*The Reno Creek ISR Project
Campbell County, Wyoming*

**Revised RAI Response Package:
Technical Report**

December 2014

FIGURE 3-5

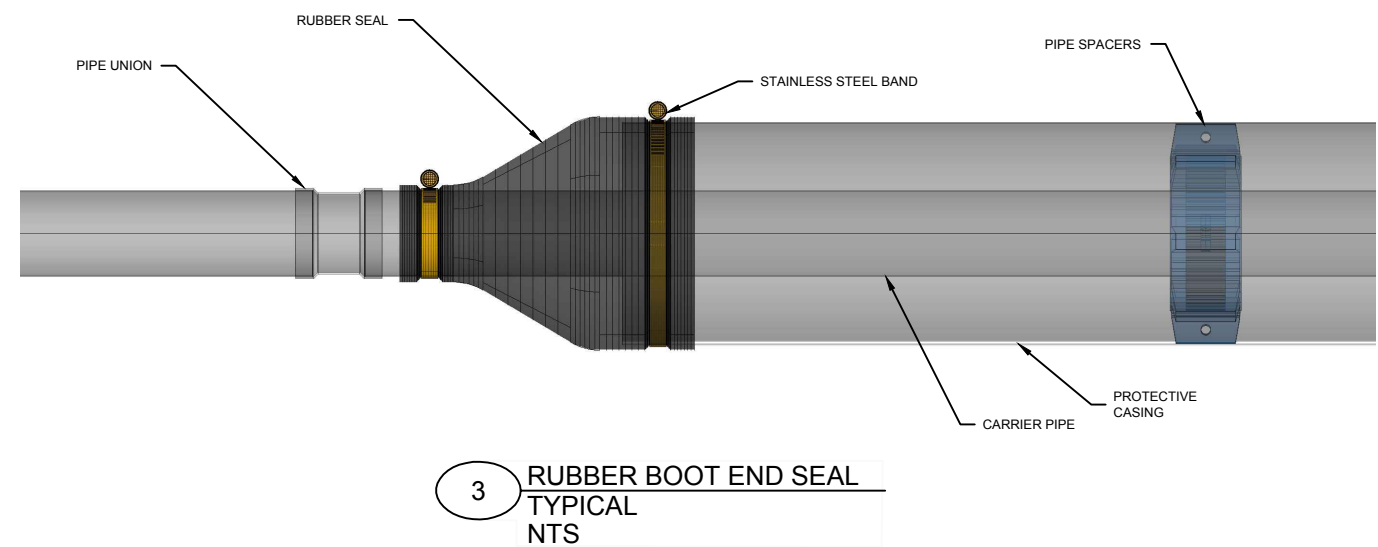
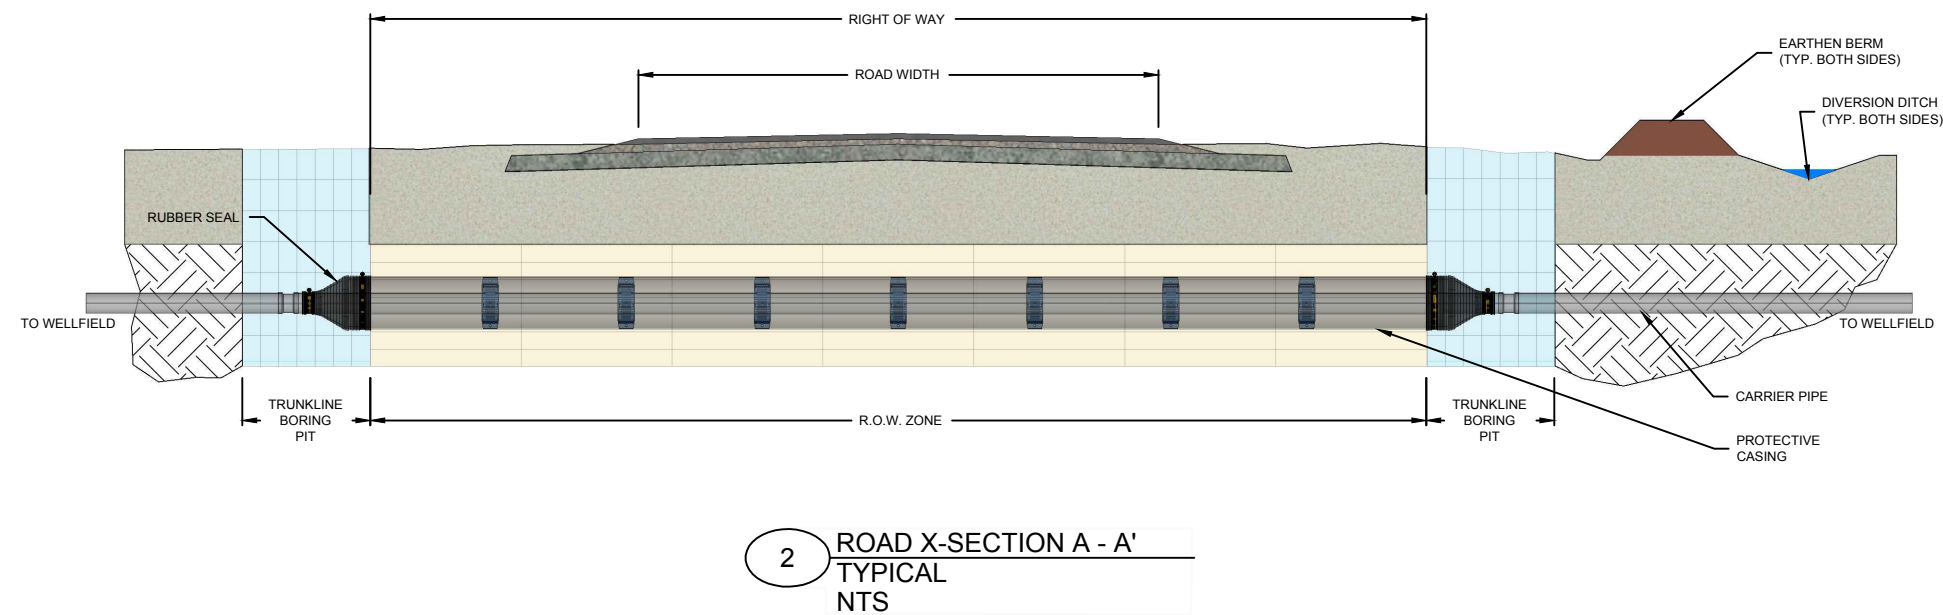
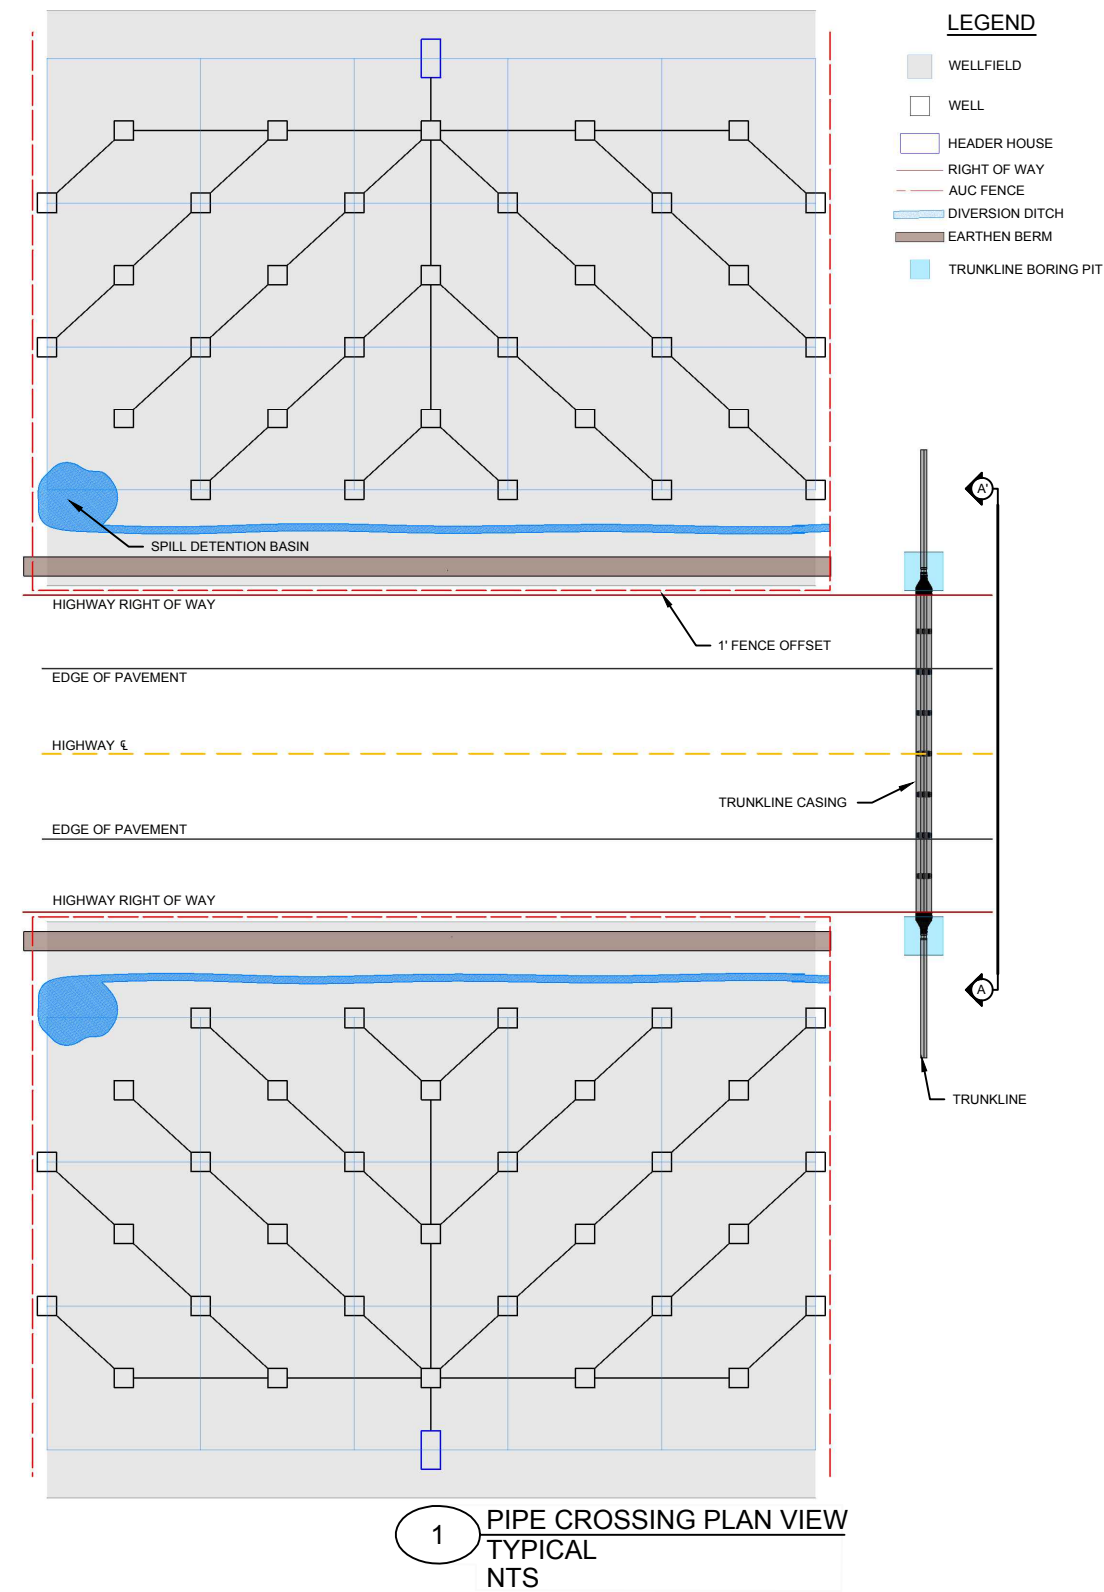
In TR Section 2.1 on Figure 2.1-3, the applicant proposes to construct wellfields that bisect by a publicly used paved road.

AUC has developed a new Figure 3-5 (shown below) to include a conceptual design of how a berm or a ditch or a combination berm/ditch within/along the AUC fence line (where the topography will allow) to control a potential leak or spill from entering the highway/county road right-of-way. A more detailed discussion of spill containment for each individual wellfield located along a highway or county road will be presented in the associated wellfield data package.

“When a trunkline is installed beneath a highway or county road AUC will use a double walled pipe system (Figure 3-5). The pipe that will be transferring the process solutions to or from the wellfields will be centered inside a protective outer pipe that will be sealed at each end to prevent a release of fluid if the carrier pipe should leak. Each double walled

TR Figure 2.5-46

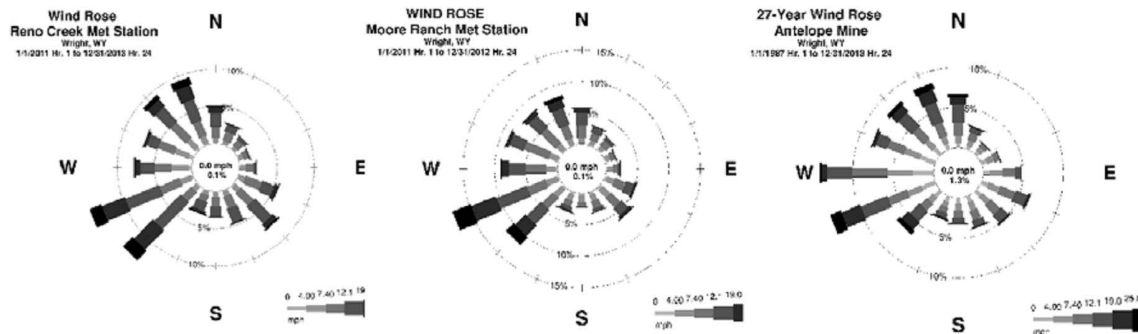
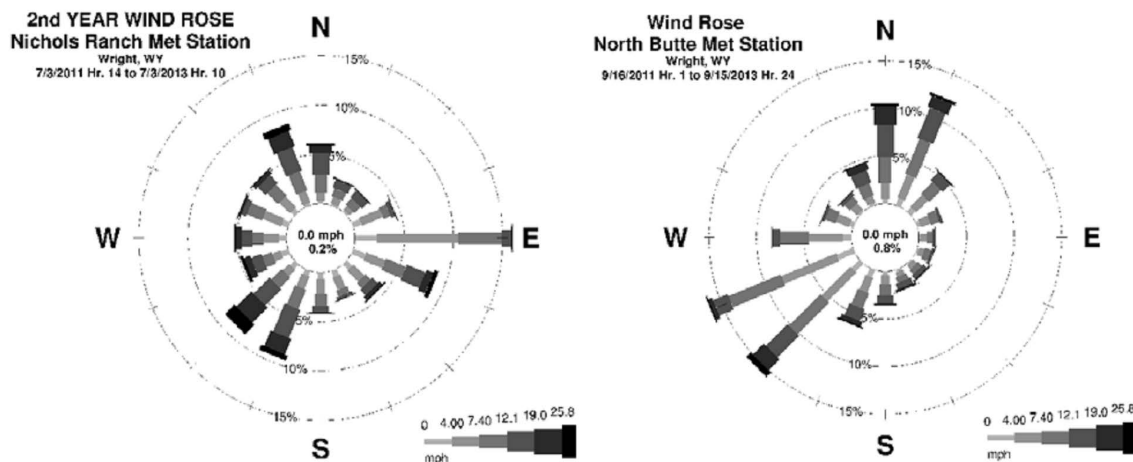
RAI-9 Response

To further support AUC's assessment of local meteorology the following text will be added to the end of TR 2.5.3.7:

roughly resembles the wind rose from Antelope Mine which is located 20 miles southeast of Reno Creek (Figure 2.5-46). All three sites experience the same regional wind pattern. Moore Ranch is approximately the same distance from Pumpkin Buttes as is Reno Creek, but in a more southerly direction.
